**BCA Assessment Report**

**Phase 2 - State Significant  
Development Application (SSDA)  
Documentation**

Walsh Bay Arts Precinct  
Pier 2 & 3 + Wharf 4 & 5, Waterfront Square

Prepared for: Infrastructure NSW  
Ref: 160144  
Date: November 2016

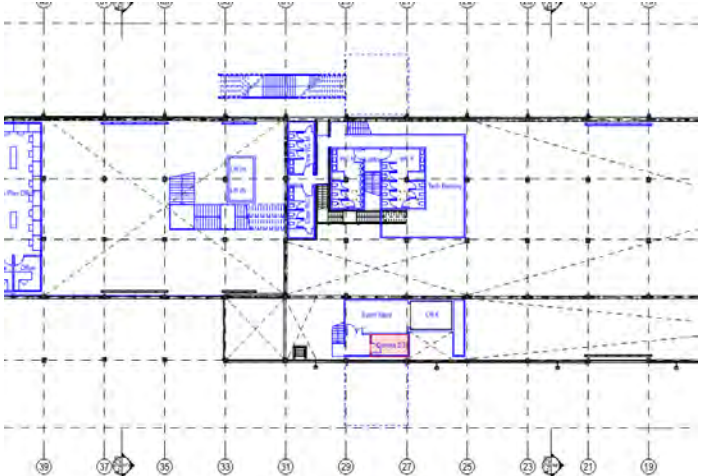
CLAUSE	REFERENCE	COMMENT																																																																																																			
C2.7	Separation by fire walls	<p><b>Further Information Required/Alternative Solution</b></p> <p>Fire walls must be constructed in accordance with the following:</p> <ul style="list-style-type: none"> <li>+ Fire walls must be constructed so that it achieves the relevant FRL prescribed by Spec C1.1 for each respective part and if they are different the greater of the adjoining part. (i.e. 120min Class 9b, 180min Class 6 and 240min Class 8)</li> <li>+ Fire Walls must extend to the underside of a floor with the same FRL, or to the underside of a non-combustible roof covering.</li> <li>+ Any openings in a fire wall must not reduce the, except where permitted by the Deemed-to-Satisfy Provisions of Part C3 (i.e. fire doors; protection of services).</li> <li>+ Building elements, other than roof battens with dimensions of 75mm x 50mm or less or sarking-type material, must not pass through or cross the fire wall unless the required fire resisting performance of the fire wall is maintained.</li> <li>+ A part of building separated from the remainder of the building by a fire wall may be treated as a separate building for the purposes of the provisions of Sections C, D and E if the wall concerned extends through all storeys and spaces in the nature of the storeys, carried to the underside of the roof covering. Notwithstanding there are additional requirements where one of the roofs is lower than the roof of another part.</li> </ul> <p>We note that the building is to be divided up into fire compartments not exceeding 2,000m<sup>2</sup> as per the fire compartmentation plan prepared by TZG architects dated 7/10/16, with the exception of 4/5 south (Refer below)</p>

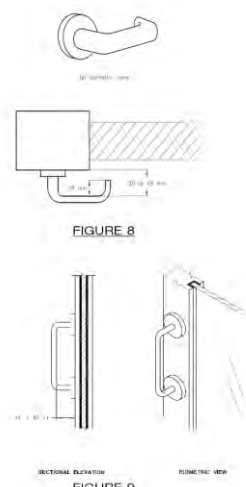
D2.19	Doorways and doors	<p><b>Further information Required/Alternative Solution</b></p> <p>We note that the plans indicate compliance is readily achievable. It appears there are a number of power operated sliding doors to the ground floor tenancies within the building. These doors are to be fitted with a failsafe device which automatically opens these doors upon fire trip within the building.</p> <p>The egress doors will be subject to further assessment as the design progresses. Notwithstanding the above, further information is to be provided with respect of the ground floor commercial 1 space which is noted as having sliding doors which are currently installed in from of the required egress doors. Given the size of these doors it is unlikely that they will be capable of being opened with a force of not more than 110N. In this regard, further information will need to be provided to demonstrate compliance. Where strict compliance cannot be achieved, the projects Fire Safety Engineer will need to develop and Alternative Solution to permit these existing doors to remain.</p> <p><b>Note 1:</b> All doorways serving the EV parts of the building must swing in the direction of egress other than those addressed by way of a fire engineered Alternative Solution.</p>  <p><i>Figure 5: Existing sliding doors requiring further review</i></p>

Figure 6: Location of fire compartment greater than 2,000m<sup>2</sup>

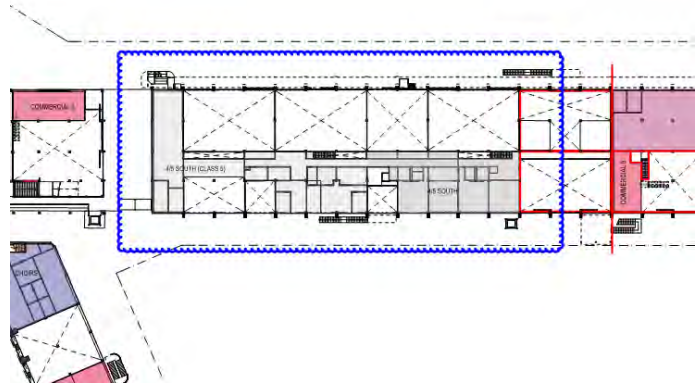
that the fire compartment 4/5 South shown below will be in excess of 2,000m<sup>2</sup> (approx. 2060m<sup>2</sup>). In this regard, the projects Fire Safety Engineer will need to rationalize smoke exhaust from this compartment.
